Tusuka Trousers & Jeans Ltd

5 February 2014

Building Observations Jeans Building

Structural Cracks

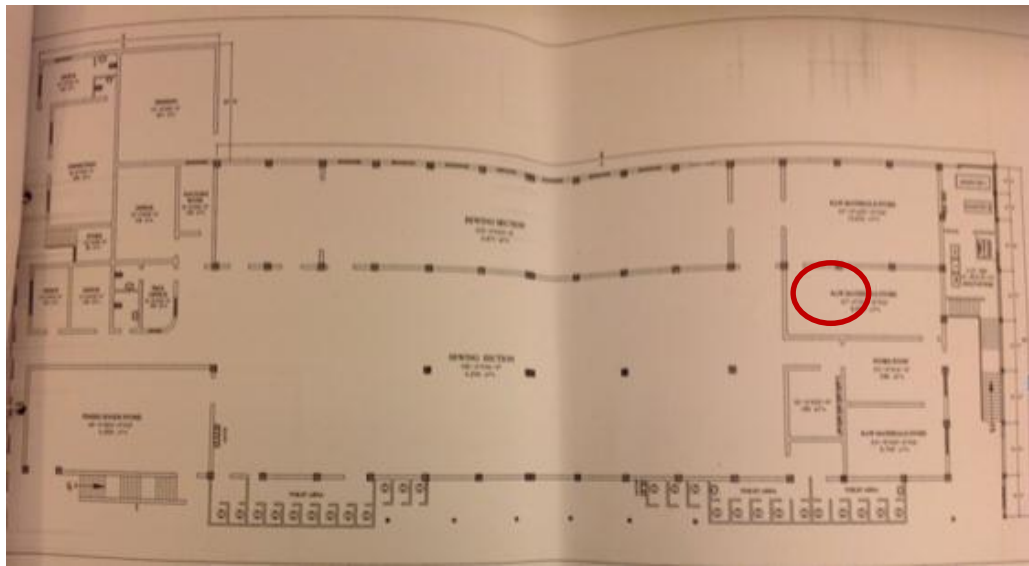
Structural cracking of concrete beams and evidence of temporary remedial measures

Significant cracks are present on the underside of the First Floor tertiary beams. Some of these beams are propped (and the props are not anchored into the base slab).

Structural Cracks

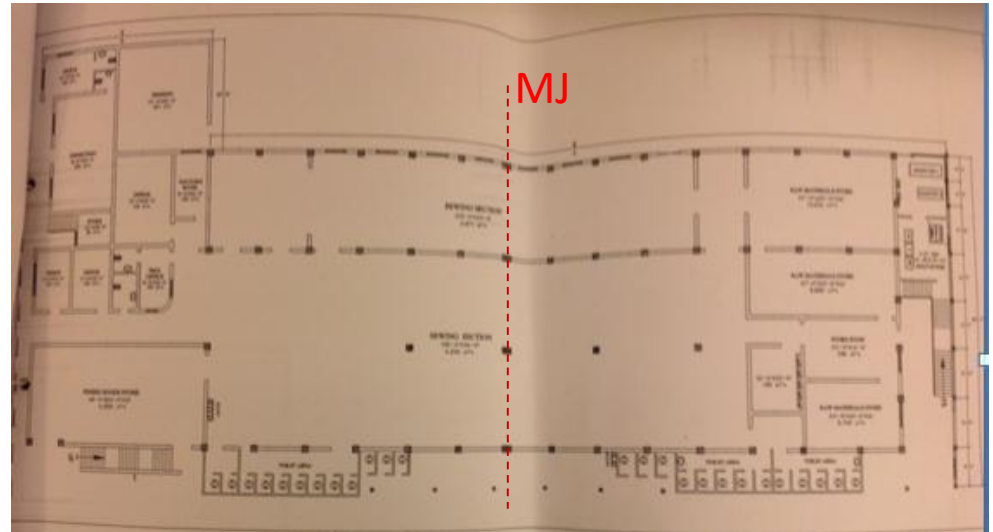
Cracking can be observed on the underside of the slab in one area.

Variable Column Material

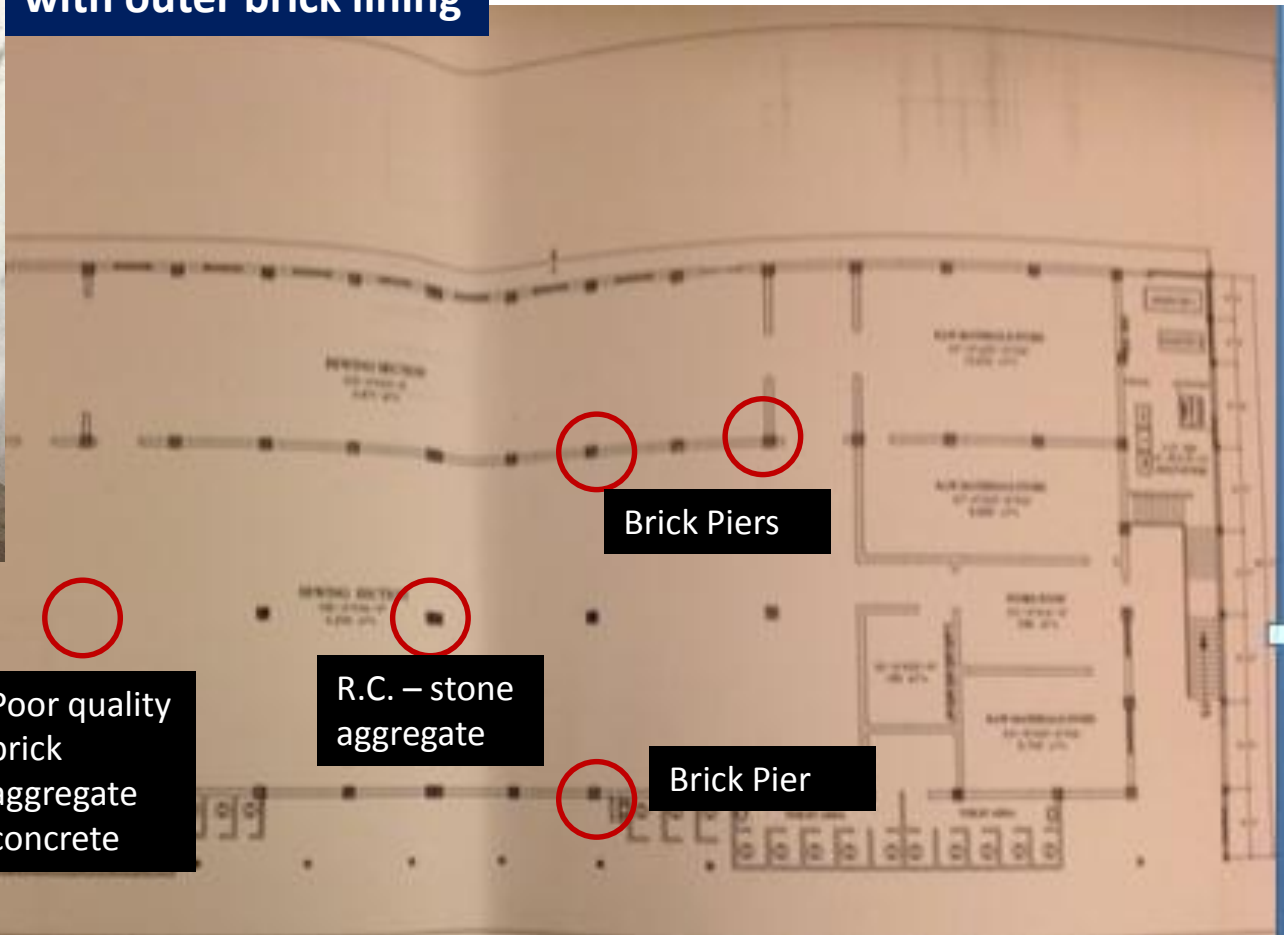
**A number of columns at ground floor level
appear to be constructed of weak brick
aggregate concrete or brickwork**

The structural information provided did not contain details of column construction. Plaster finish to columns was removed and poor quality brick aggregate with high voids content and apparent brick columns were evident.

1st Floor Roof

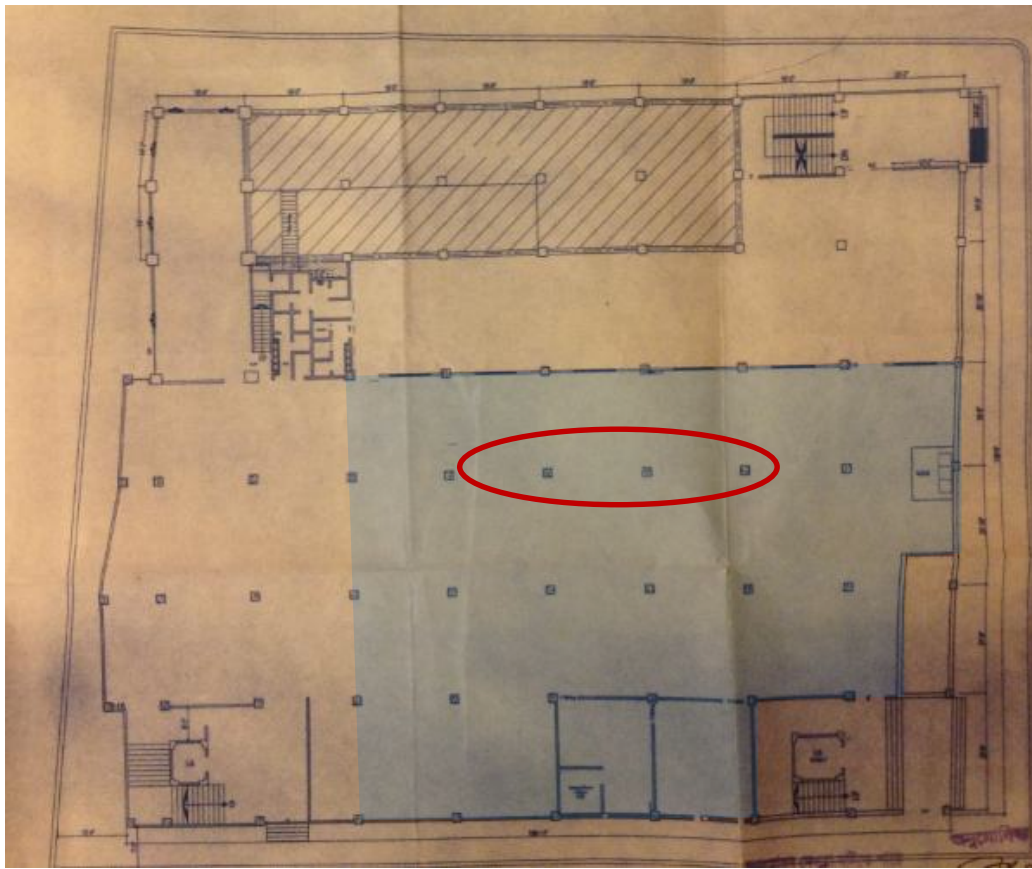
Cracking at Connection of Lightweight Roof

Bottom chord of truss discontinuous

The lightweight roof requires a full structural review.

Cracking to Ground Floor Slab

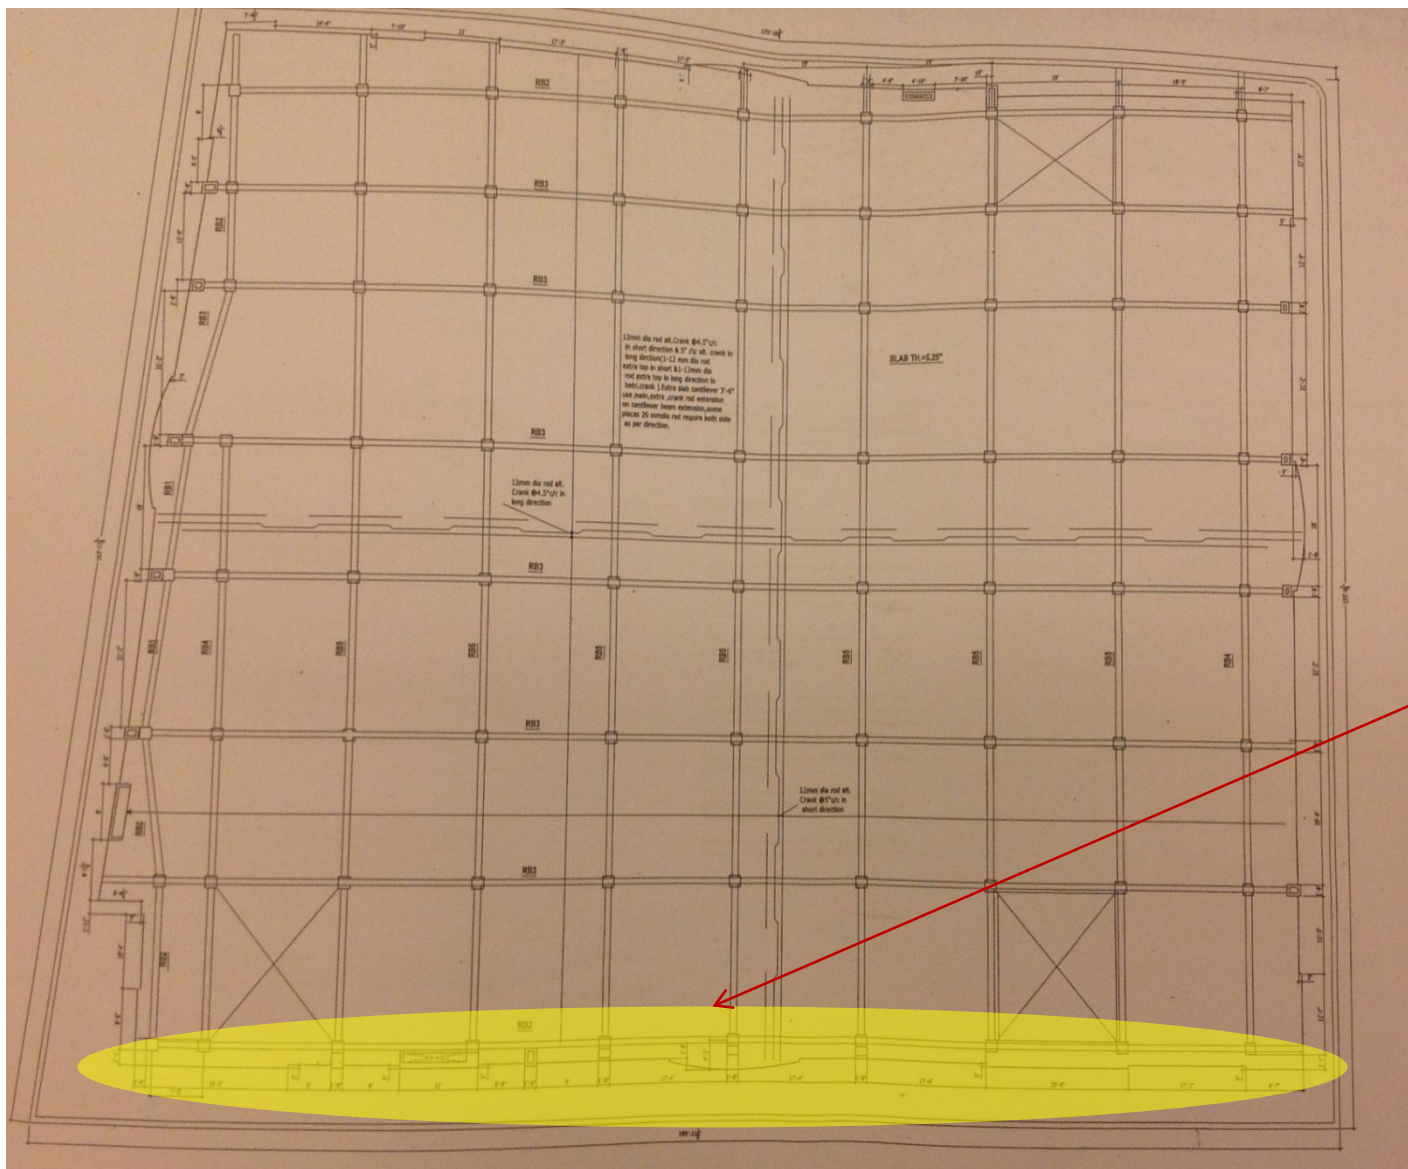
Cracking to top of suspended ground floor slab over basement

**Building Engineer to review cracks in Ground Floor
finishes for potential structural implications.**

12	Cracking to top of suspended ground floor slab over basement	Produce and actively manage a loading plan for all floors within the building giving consideration to floor capacity and column capacity	6-weeks
13	Cracking to top of suspended ground floor slab over basement	Continue to implement load plan	6-months

Load Management

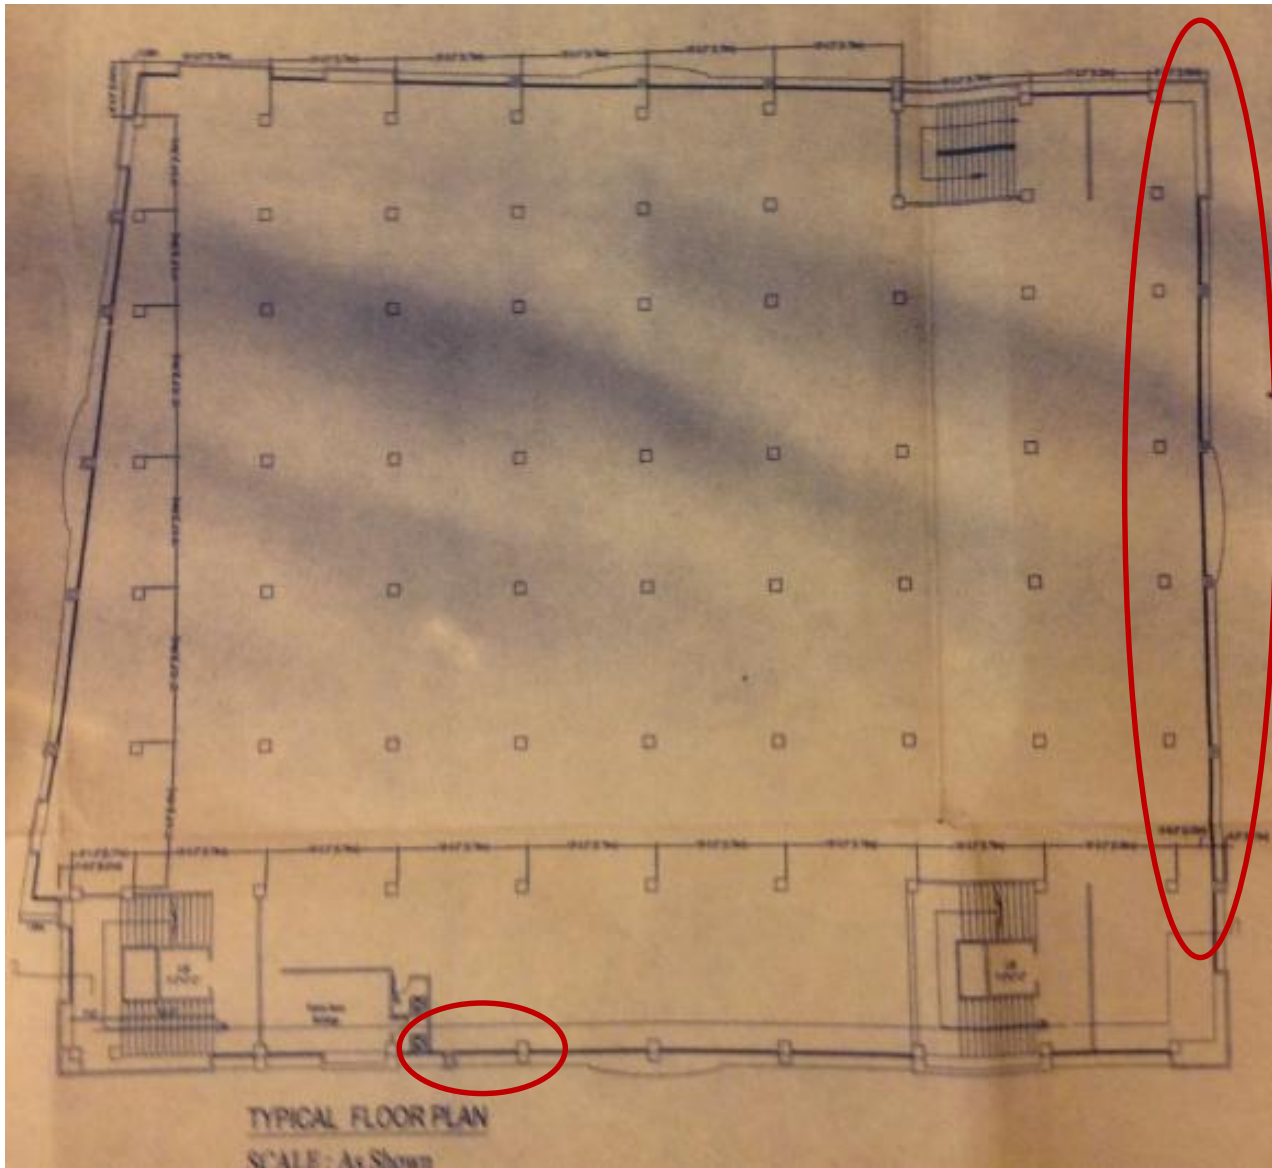
Load management of storage loads

**Storage loads were observed on the 1st, 3rd, 6th and 7th floors.
Load management plan to be prepared by the Building Engineer and height restrictions to be introduced to prevent future overloading.**
